**RE: Baylor Drive Property
2635 Baylor Dr. SE
Grading and Drainage Plan
Engineer's Stamp Date: 10/16/20
Hydrology File: M16D044**

**RE: BAYLOR DRIVE PROPERTY
2635 BAYLOR DR. SE
GRADING AND DRAINAGE PLAN
ENGINEER'S STAMP DATE: 08/07/19
HYDROLOGY FILE: M16D044**

GRADING AND DRAINAGE PLAN

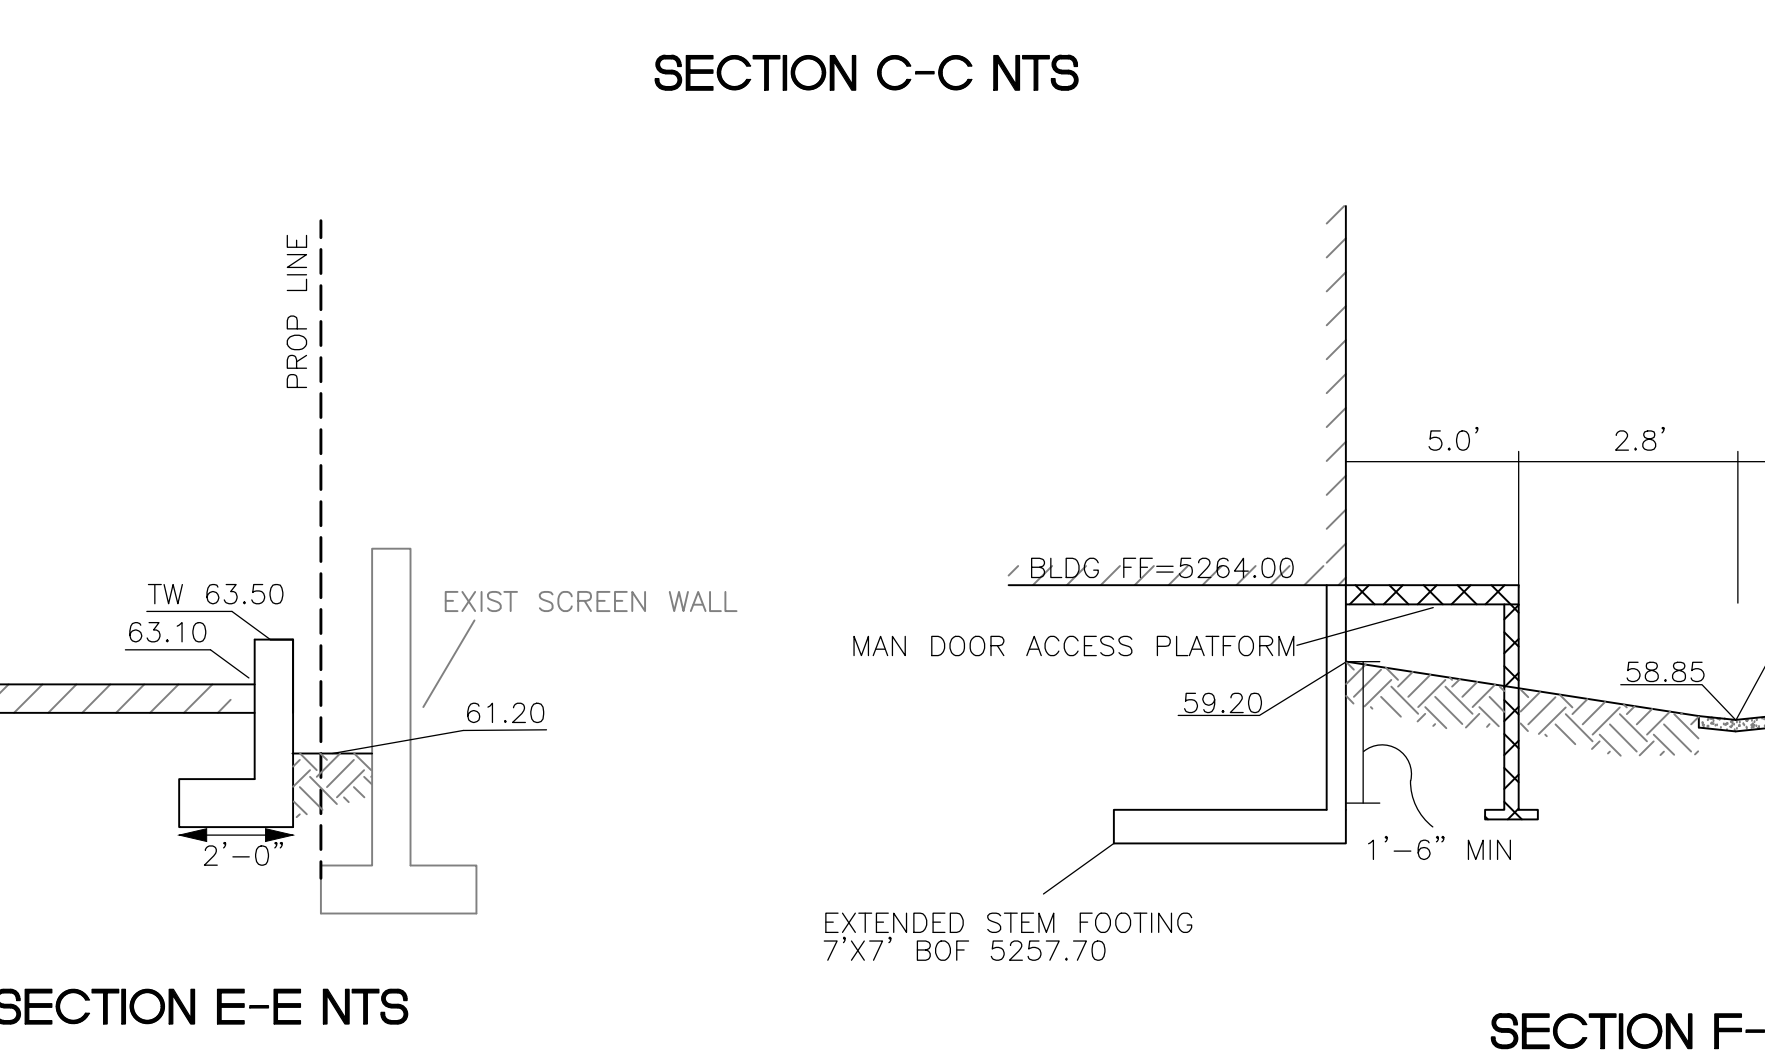
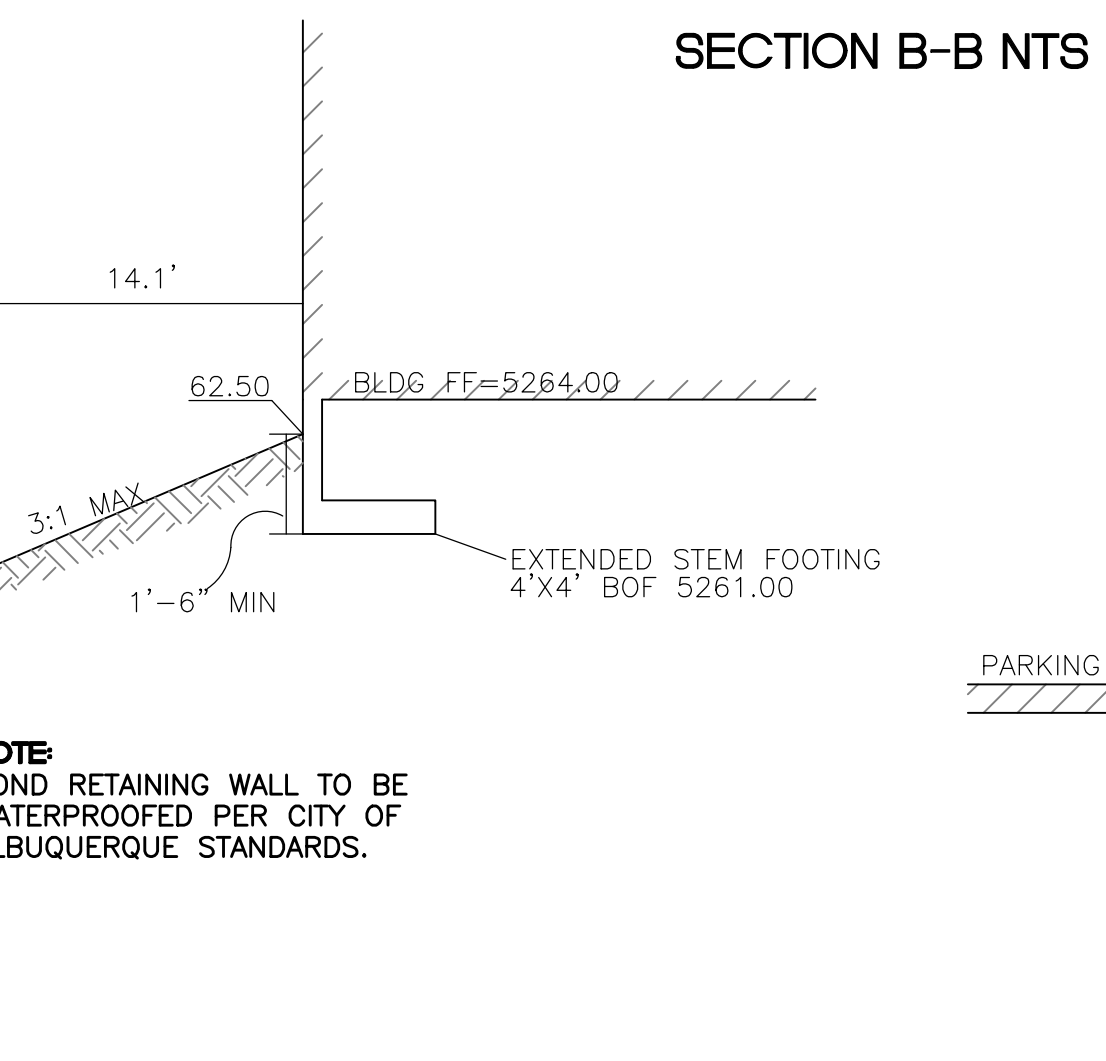
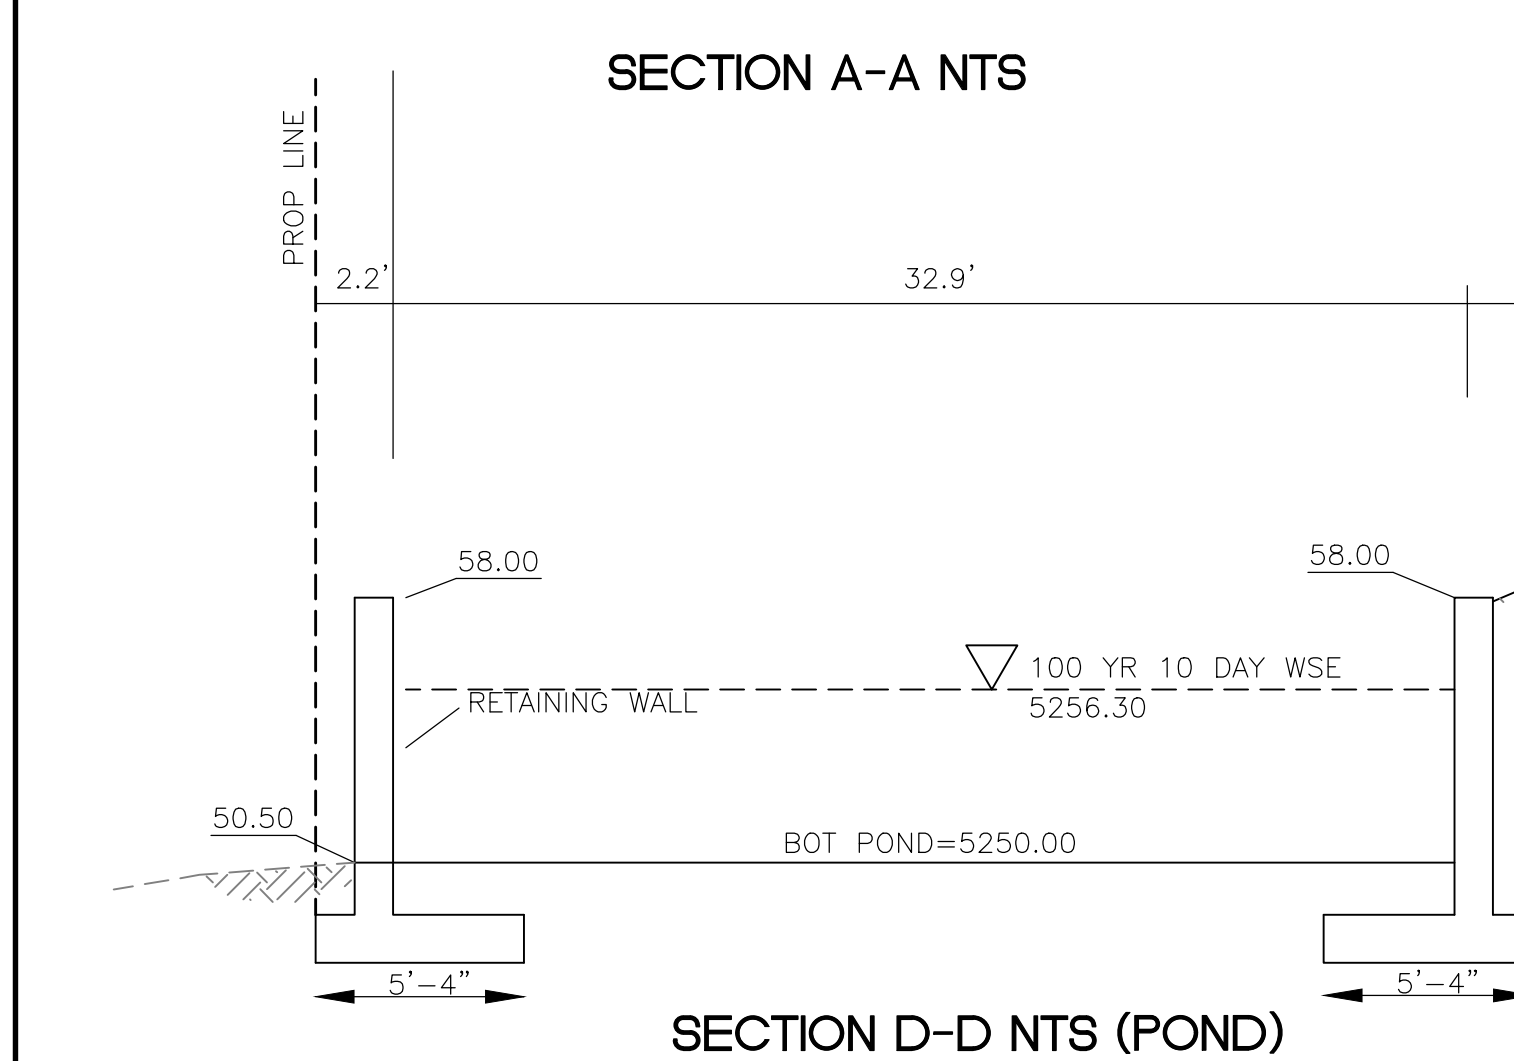
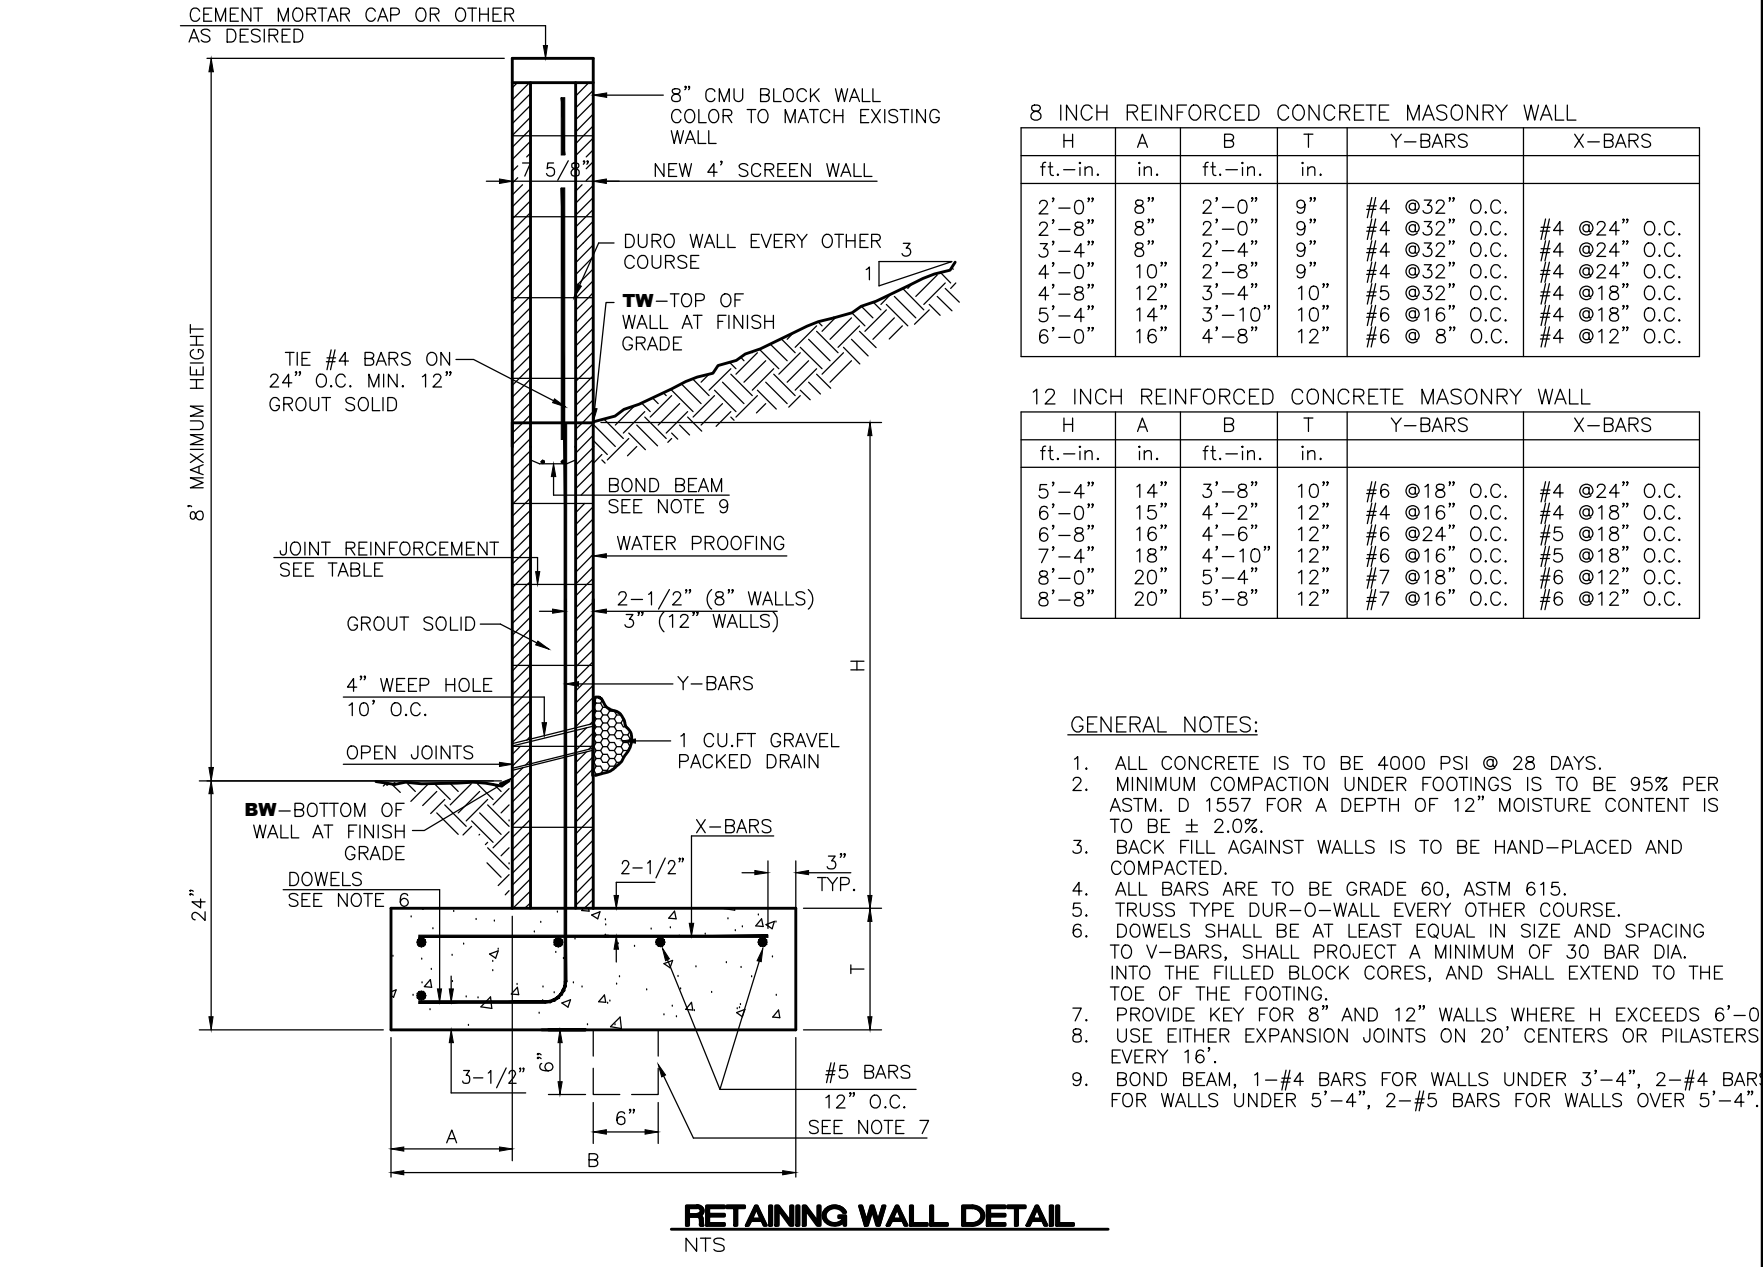
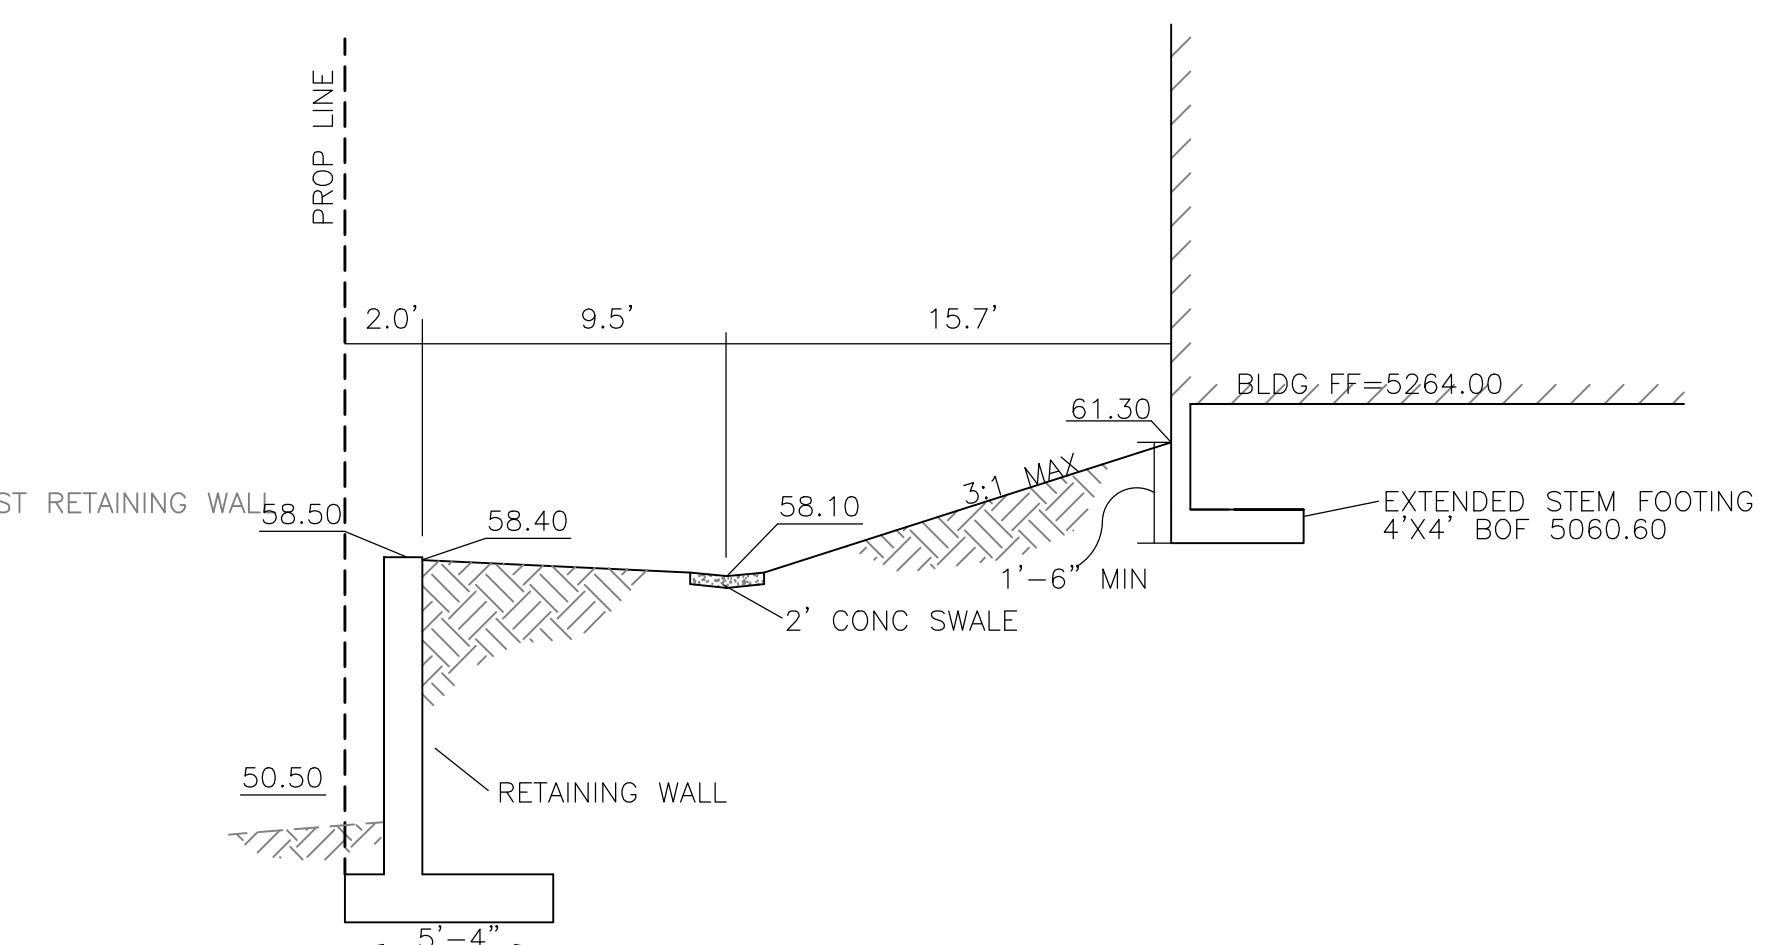
2. Provide sections through all external boundaries showing proposed retaining walls, garden walls, property/ROW lines, existing and proposed grades. In accordance with DPM Ch. 22, section 5 part B, grading and wall construction near the property line may not endanger adjacent property or constrain its use.

4. Please provide a cross section of the proposed retention pond showing dimensions, the bottom elevation, the top of wall, and the water surface elevation of the 100 year 10 day volume.

Response: Sections have been added to GR-2.
3. If the proposed retaining wall will create such an encroachment, written agreement from both landowners must be provided for such work. Written permission must include: signature of the property owner or owners representative, statement that undersigned is the owner or authorized representative, permission to construct the encroachment with a brief description of the encroachment.

Response: A pond section has been added to GR-2.
5. Please provide a detail of the proposed 2 ft concrete channel entering the walled retention pond.
Response: A detail of the concrete channel entering the walled retention pond has been added to GR-2.
